City of Franklin

Meeting Agenda

Historic Zoning Commission

Monday, September 14, 2026

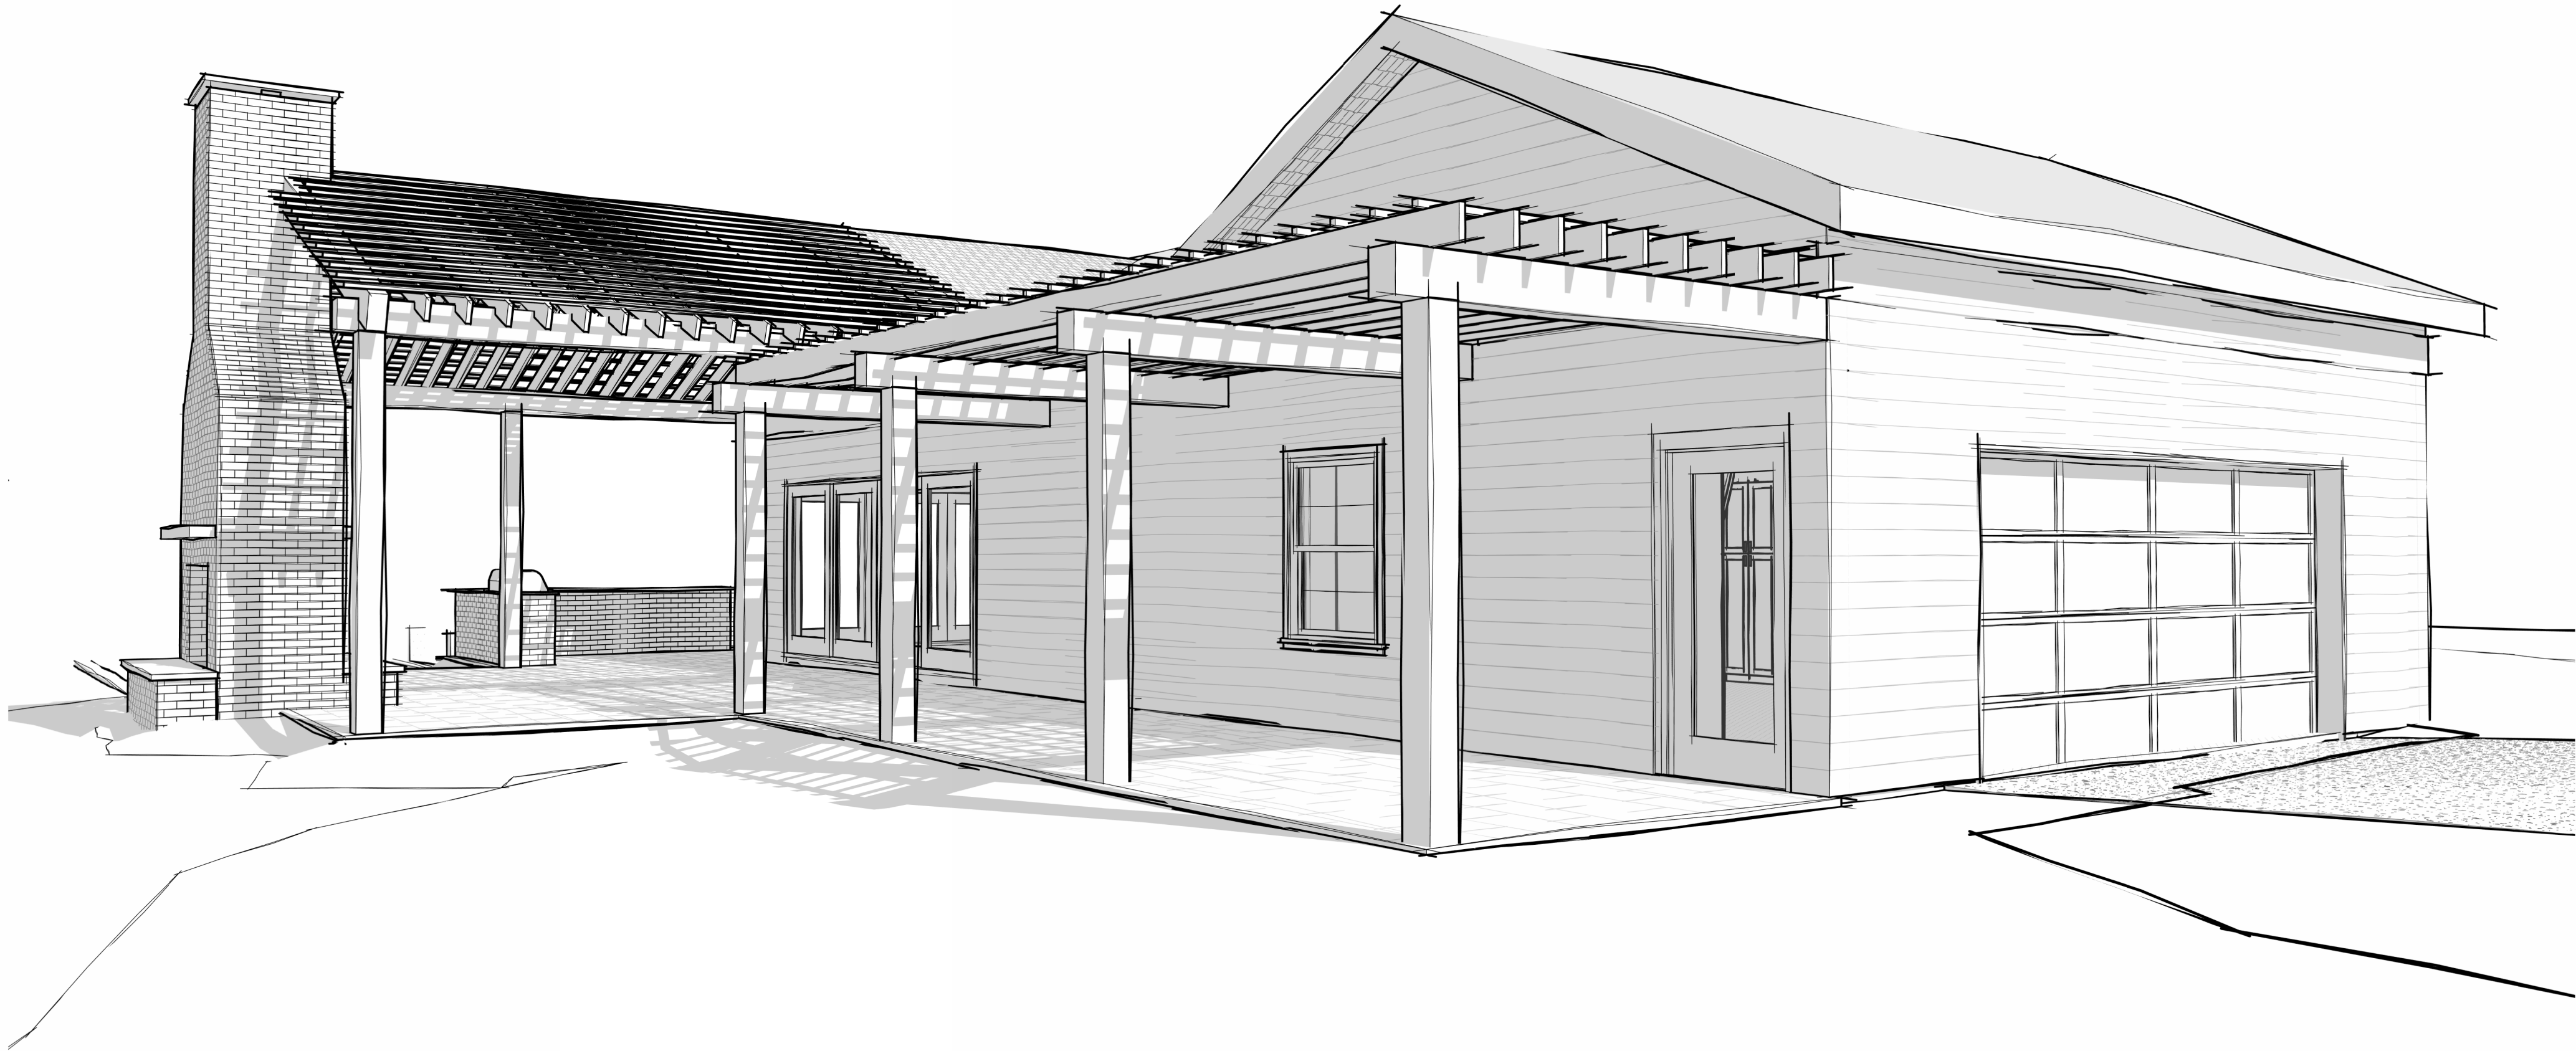
For the accessory structure, the proposal includes further extending the gabled pergola and constructing a brick fireplace and chimney. The fireplace and chimney will be positioned behind the main plane of the principal building. Outside of the accessory structure, an outdoor kitchen with a counter and grill is proposed. Patio pavers are proposed surrounding the grill and around the accessory structure. The Guidelines recommend:

- Avoid the use of chimneys on accessory structures. Freestanding outdoor chimneys may be appropriate if sited so that they are not readily visible from the street.

- Site and setting alterations should be considered as appropriate when they are undertaken in locations that are not visible from public view, do not involve the removal of historic features, and do not detract from or overwhelm the context of the historic districts.

The pergola's placement, with the chimney and fireplace at the end, does not appear to be highly visible from the street. The application notes that the trellis/pergola will remain open and uncovered. The trellis/pergola shall not have a mechanism so that the open roof design becomes a closed roof. The pergola must remain open-roofed because a closed roof would increase the building footprint calculation and exceed the Guidelines recommendations and Zoning requirements. The outdoor kitchen location does not appear to be highly visible from the street. The pavers in the rear yard are appropriate. Information on the size, color, and appearance has not been provided, but they will not be visible from the street in the proposed location. Further, no alterations to the accessory structure's footprint or the principal building's footprint are proposed to be altered with this application. As proposed, the application meets the intent of the Guidelines.

1. The trellis/pergola shall not have a closed roof, nor have a mechanism that allows the open roof design to be closed.
2. No changes to the principal building have been approved by this application.
3. The application must meet all the requirements of the City of Franklin prior to issuance of a building permit.
4. Any additional changes to the approved plans must be returned to the Preservation Planner or the Historic Zoning Commission for review and approval.

PROPOSED ELEVATIONS
CLIFF AND LINDA WHITMORE

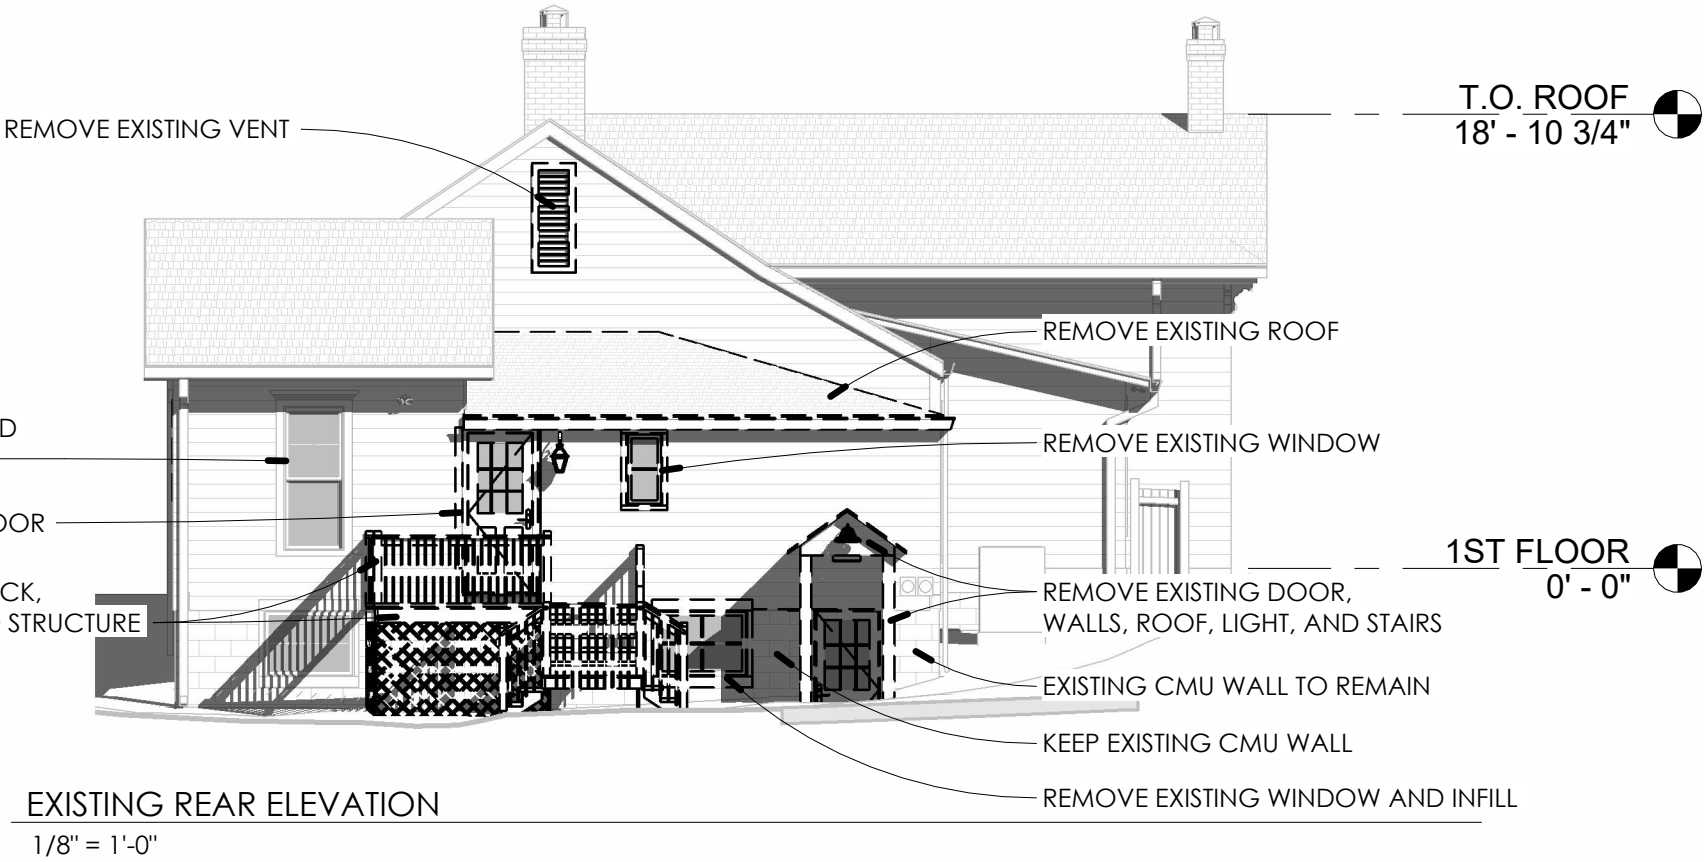
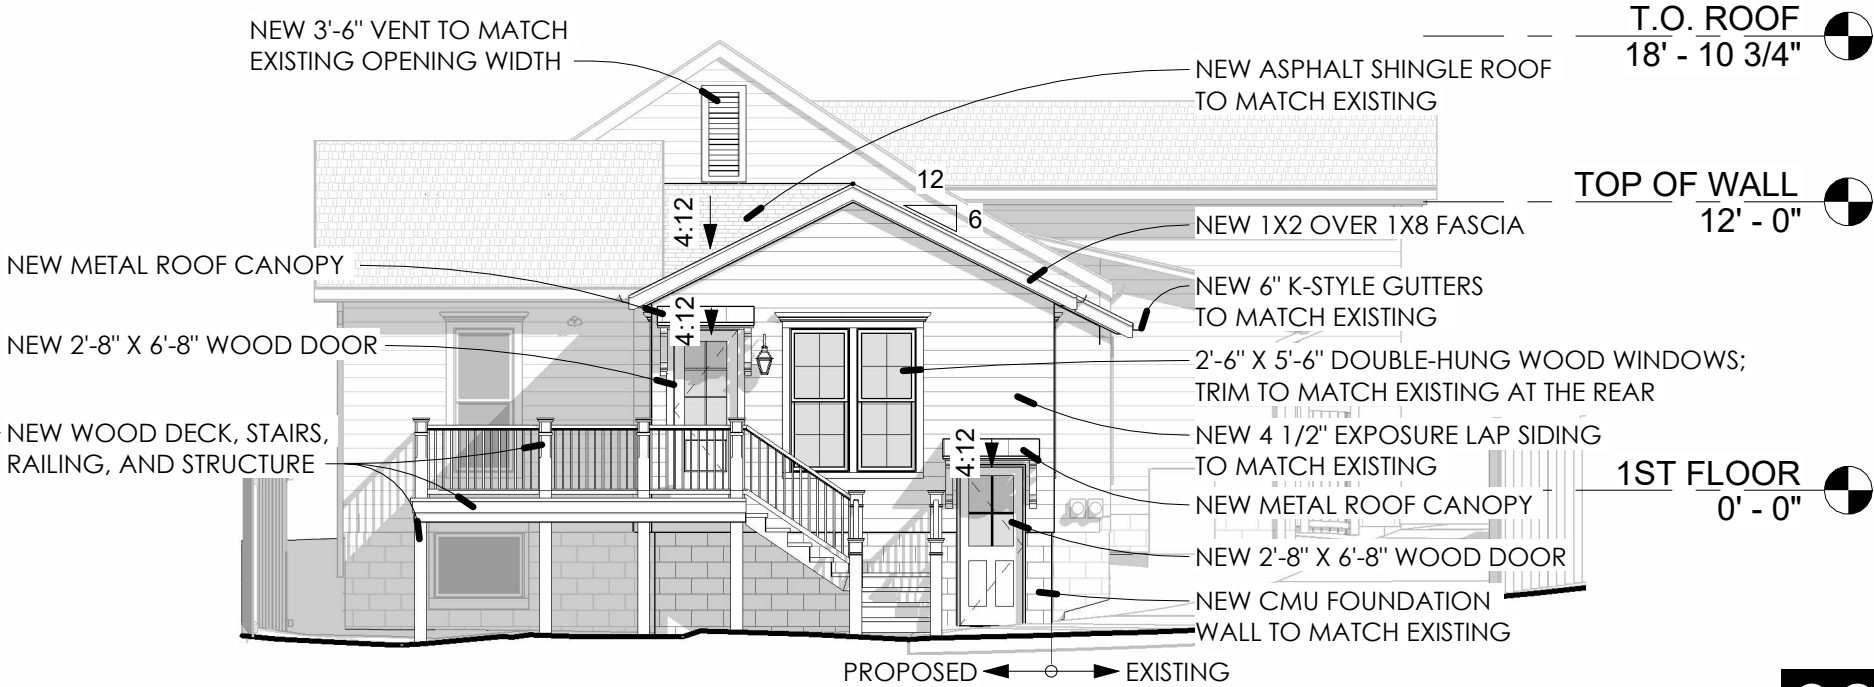
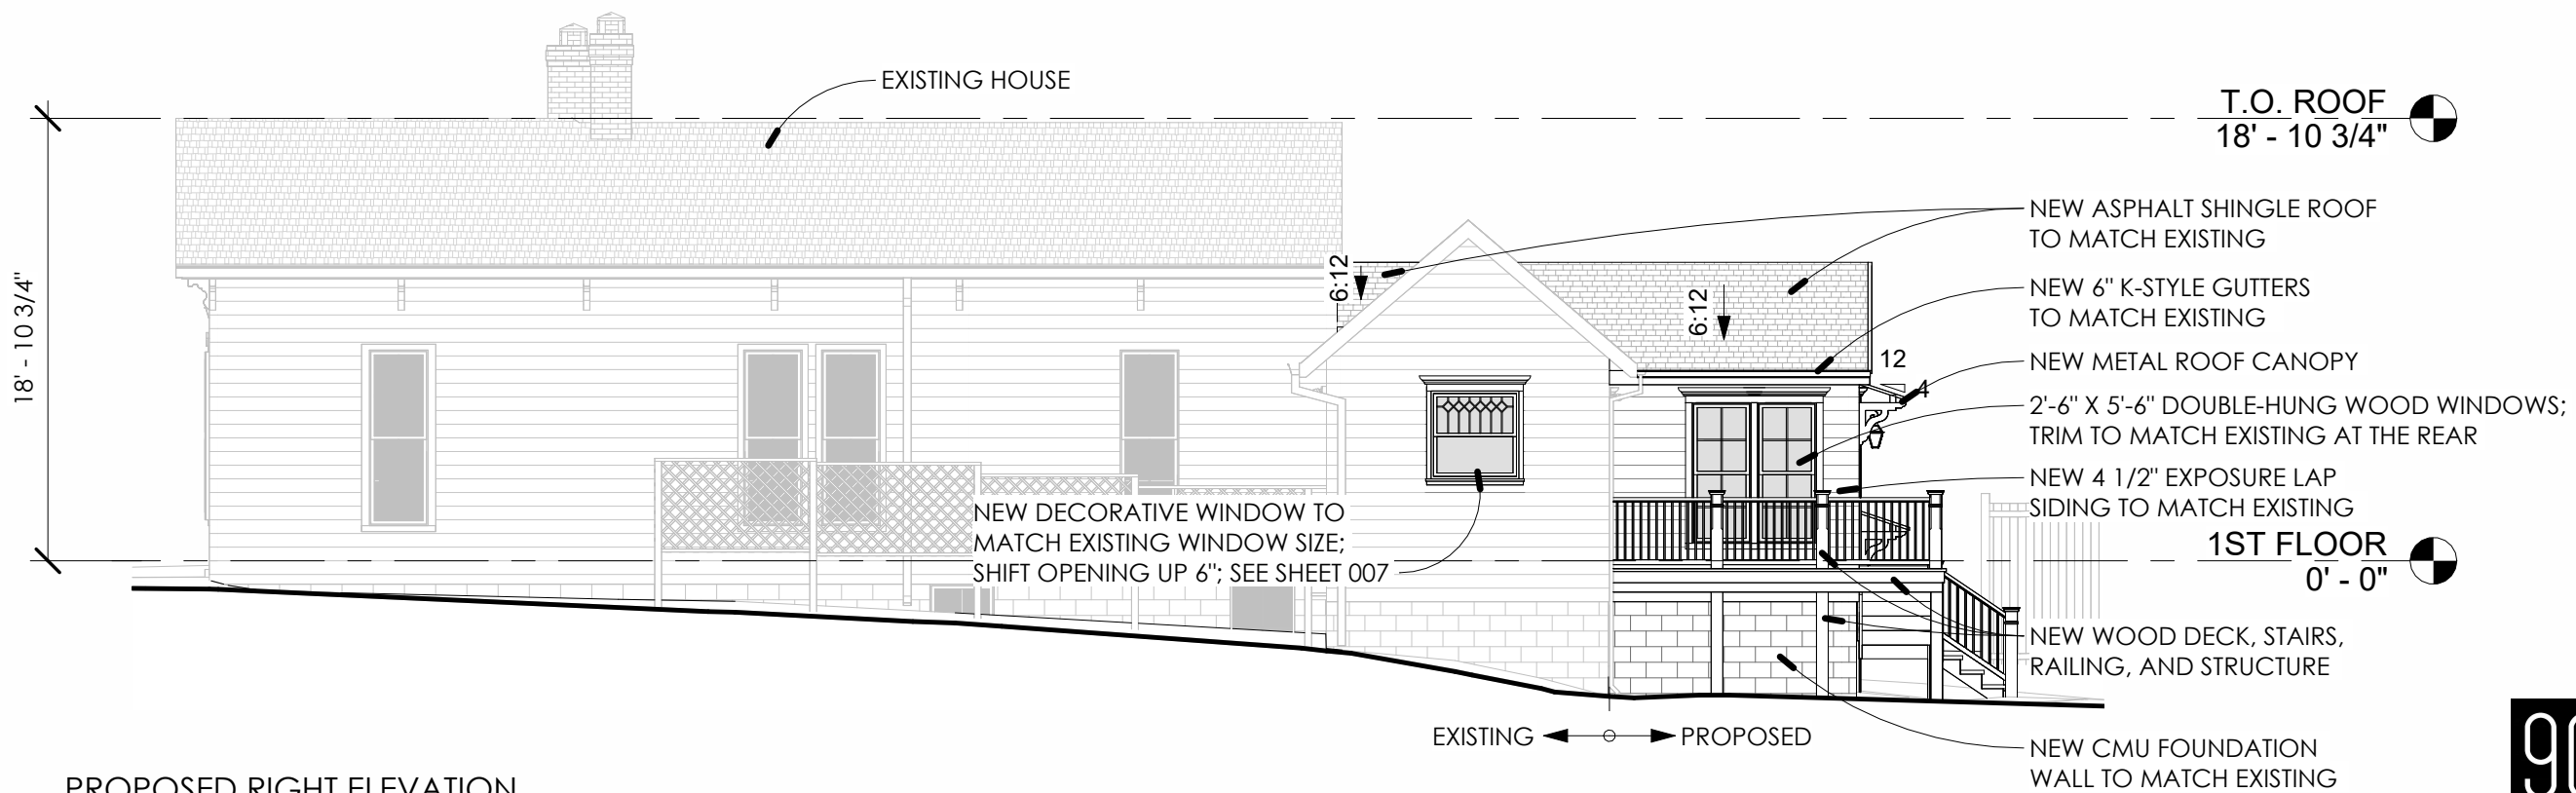
PURPOSE:
The purpose of this memorandum is to provide information to the Historic Zoning Commission concerning an addition and alteration to the historic building at 109 7th Avenue North.

1. The material composition of the lap siding must be clarified with the Preservation Planner prior to Building Permit issuance and must be either cementitious or wood in composition.

2. The addition reveal must be consistent with the reveal of the principal building.
3. The light fixtures must be submitted to and approved by the Preservation Planner prior to purchase and installation.

4. The window and door specifications must be submitted to and approved by the Preservation Planner prior to Building Permit issuance.
5. Any changes to the rear hardscaping to meet LSA requirements must be documented with the Preservation Planner and may require a COA prior to Building Permit issuance.
